SUBJECT: Addendum No. 1
City of Lookout Mountain, GA
Chickamauga Trail Pump Station Improvements

ADDENDUM NO. 1

CHICKAMAUGA TRAIL PUMP STATION IMPROVEMENTS

CITY OF LOOKOUT MOUNTAIN, GEORGIA
GEFA LOAN NUMBER: GF2024017
CTI PROJECT NO. G24017-01

DRAWING NO.
E-003.1

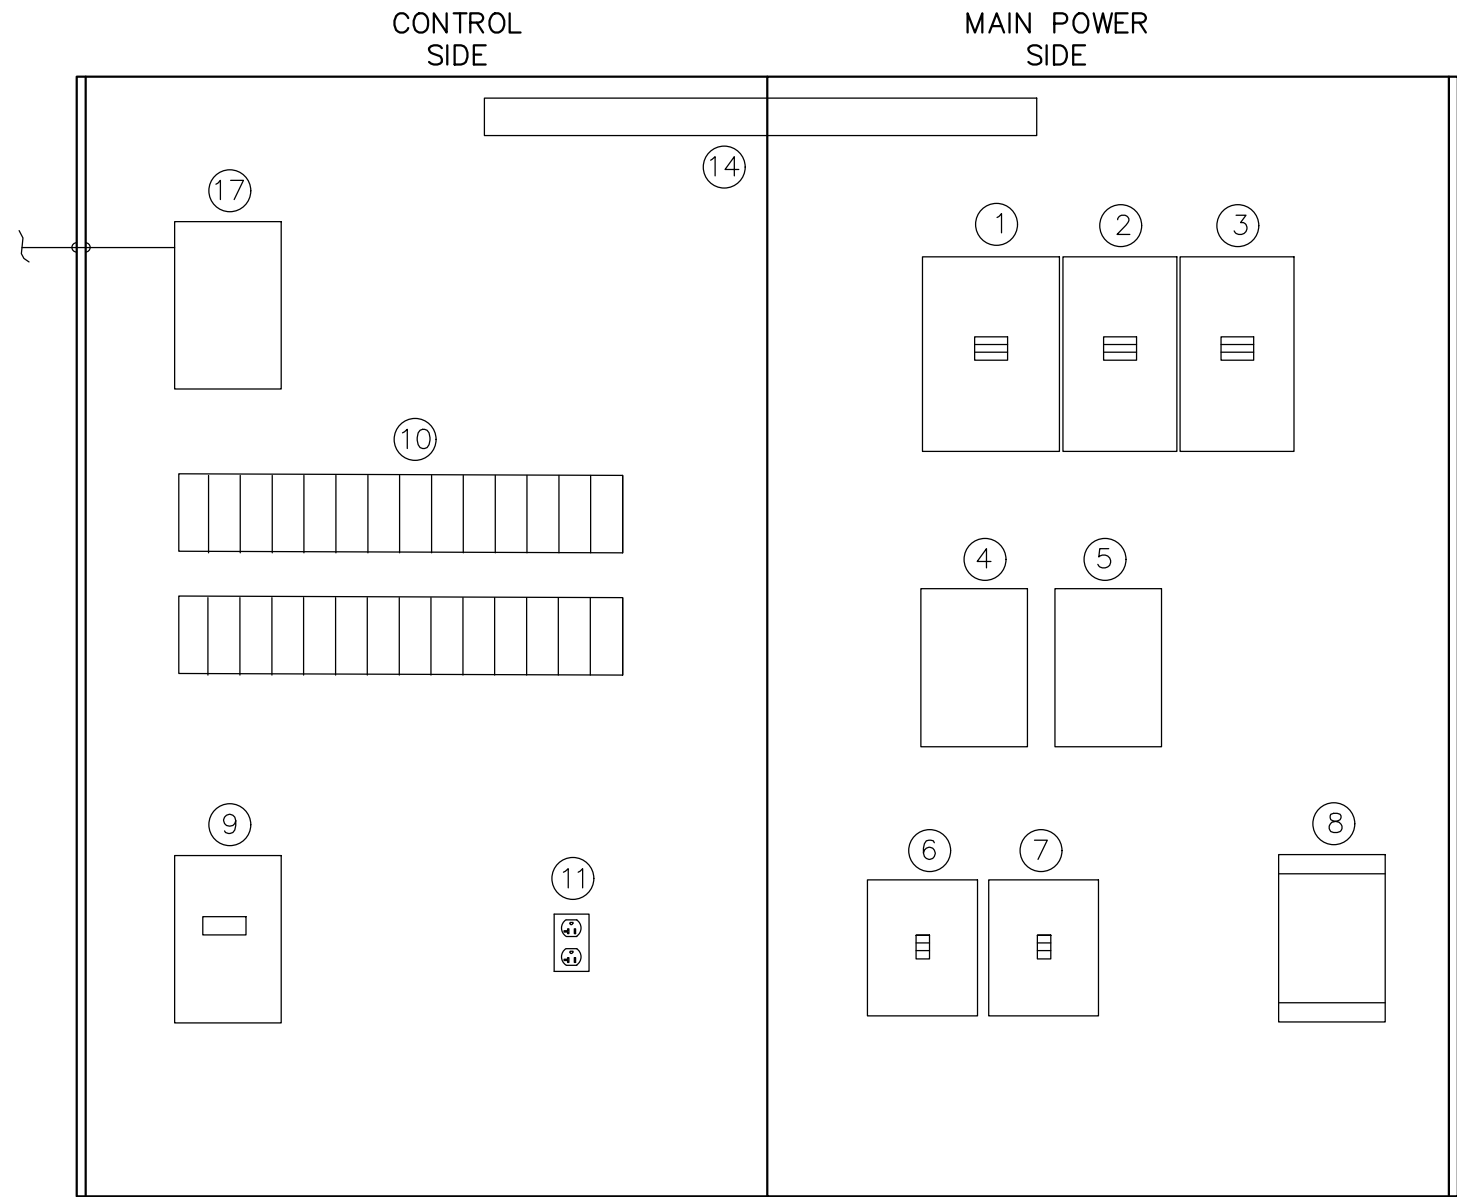
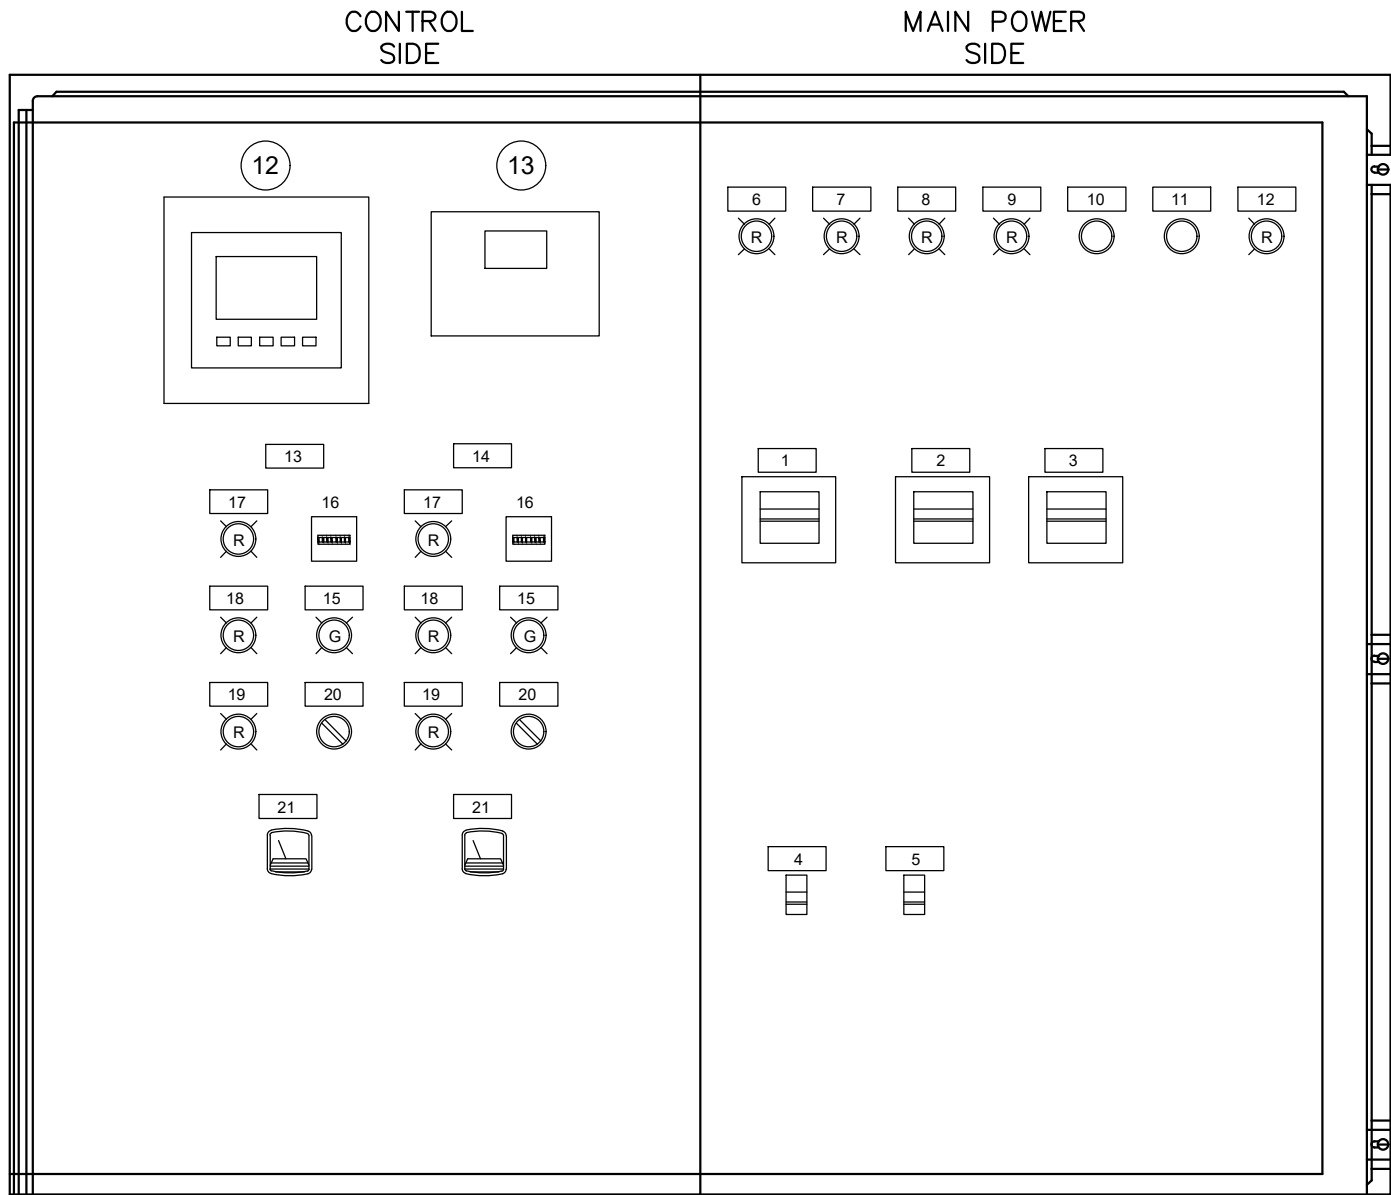
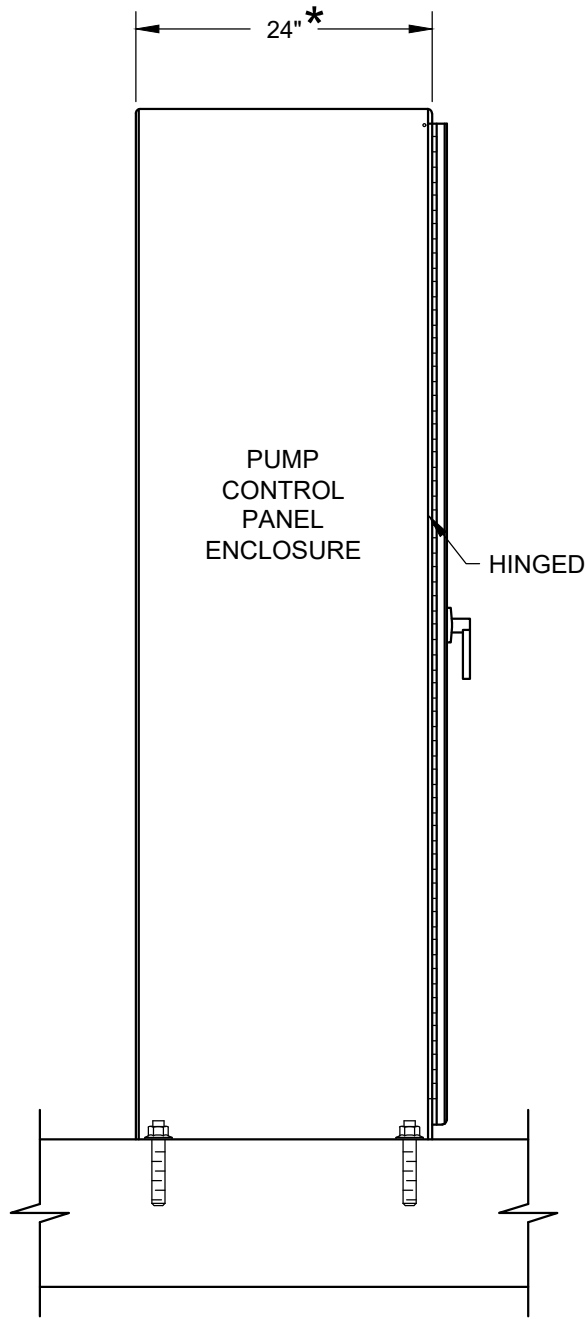
NO.	REVISIONS	DATE	BY	APP'D
1	REVISED LABELS & DIMENSIONS	08/25	GMC	GMC
